Rep 21

Representation SA2022/046 – 155 Rheban Road, Orford

I wish to express my concern over the proposed rezoning and subdivision at 155 Rheban Rd, Orford.

Figure 3. 2013 surface wind roses (m/s) predicted at the STP by TAPM.

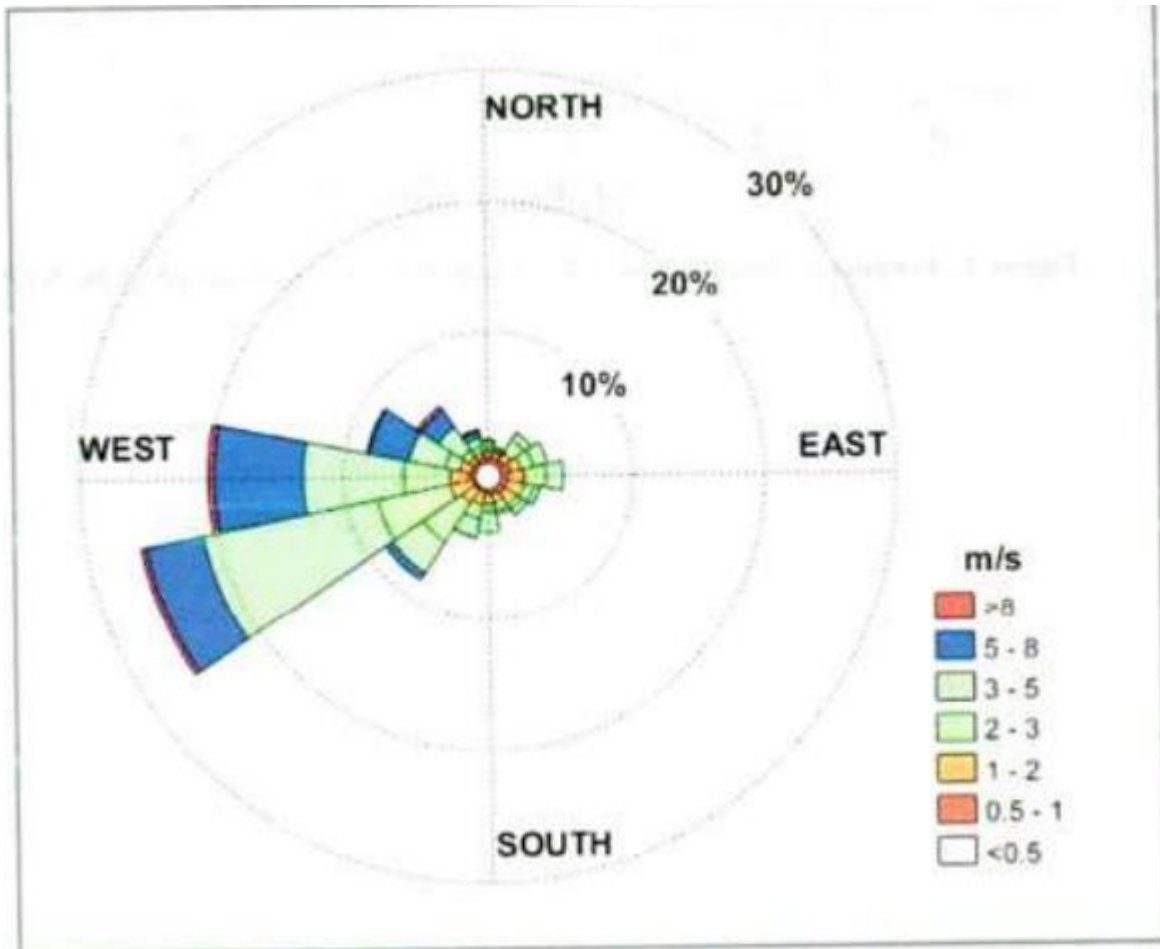
- The modelled wind file used in the odour study does not match the measured winds at Orford from the BOM 1968-2022 dataset. As a result, the odour contours are incorrect. Further, aggregating the 9am and 3pm data averages wind speeds, therefore under-represents the significant periods of calm wind which are the primary source of concern for odour.

Modelled Winds used in the Odour assessment.

Rose of Wind direction versus Wind speed in km/h (01 Aug 1968 to 10 Aug 2022)

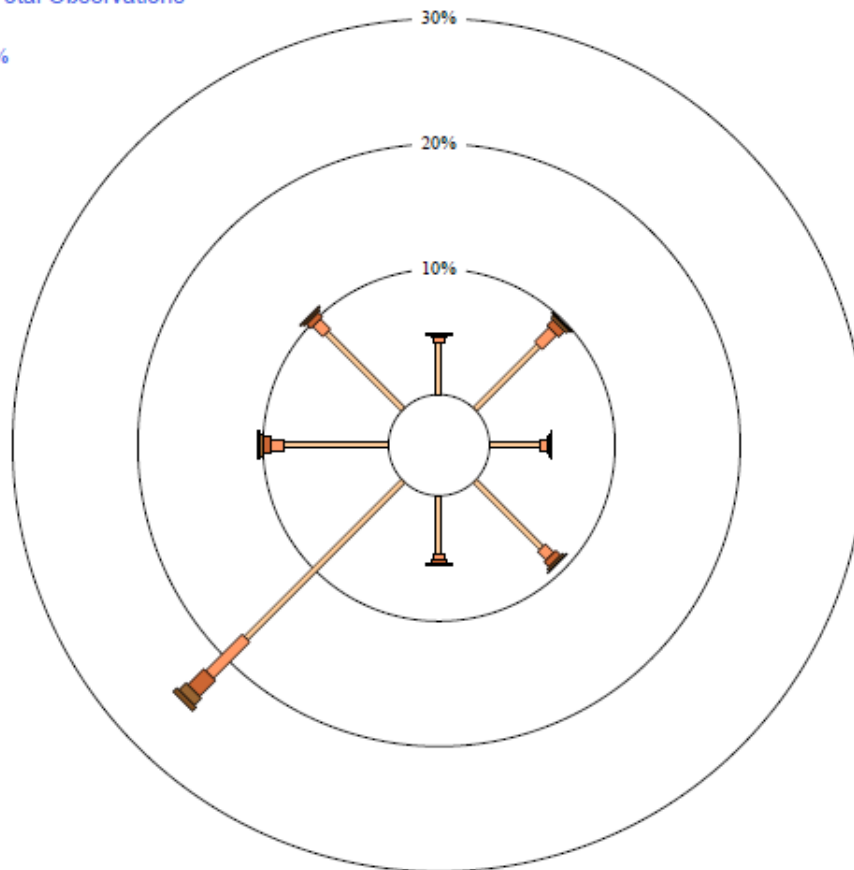
Measured Winds at Orford 1968-2022
